Contract Program or Project Title: Thermal Fuels Behavior Program, EG&G

Subject of this Document: Revision to EGG-TFBP-5221

Loss-of-Coolant Accident Series, TC-3, Experiment Operating Specification

DOCUMENT REVISION REQUEST

Figure 1 : TC-4 Fuel Rod
Orientation and Instrumentation

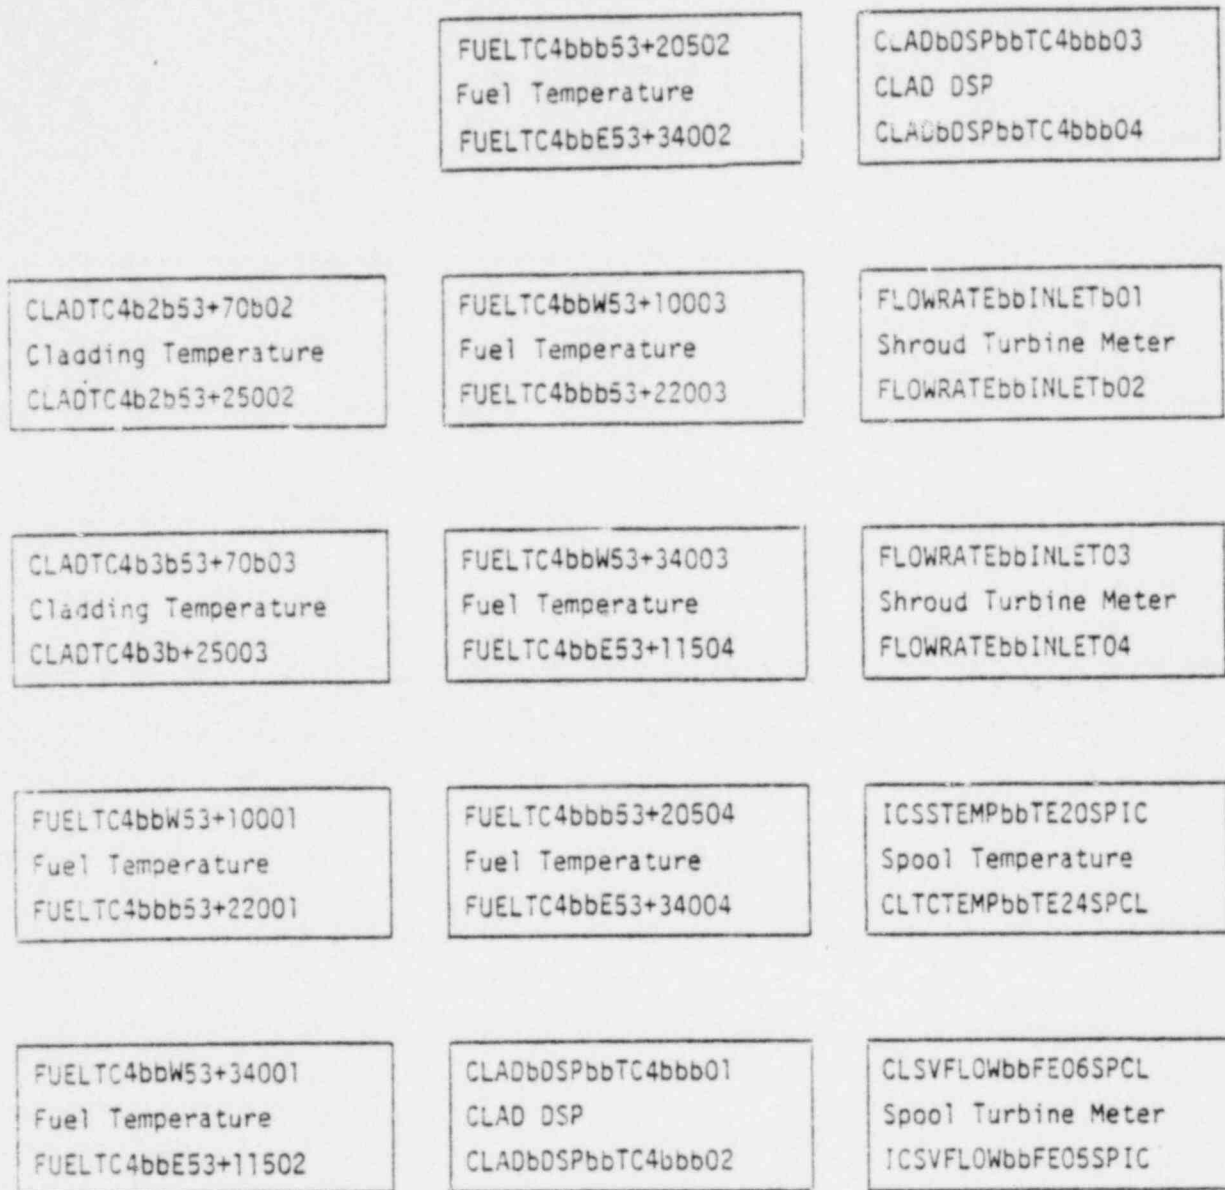
ITEM	PAGE	STEP OR PARA.	INSTRUCTIONS: REWRITE PARAGRAPH(S) OR FOR EXTENSIVE CHANGES ATTACH REVISED COPY AND STATE "REVISE PER ATTACHED COPY" FOR NEW DOCUMENT. ATTACH ROUGH DRAFT AND STATE "PREPARE NEW (SP, DOP, ETC.) PER ATTACHED DRAFT"
1	1	2	Include a statement, "This EOS will also apply for TC-4".
2	2	2	Include the sentence, "The TC-4 test will consist of two rods from TC-3 (Rods 01 and 03) and two newly fabricated test rods (Rods 02 and 04) with embedded cladding thermocouples."
3	--	--	Replace the original TC-3 EOS pages with the attached pages.
4	29	2	Change "CLADTC3b6b53+70b02" to "CLADTC4bbb53+70b02."

⑩ JUSTIFICATION: (REASON FOR CHANGE — NUMBER TO CORRESPOND TO ITEM NO. ABOVE): 1-4. TC-3 has been extended to TC-4 with two newly fabricated test rods. The hot leg Henry nozzle size has also been modified to decrease the slug velocity.	⑪ OTHER DOCUMENTATION AFFECTED:
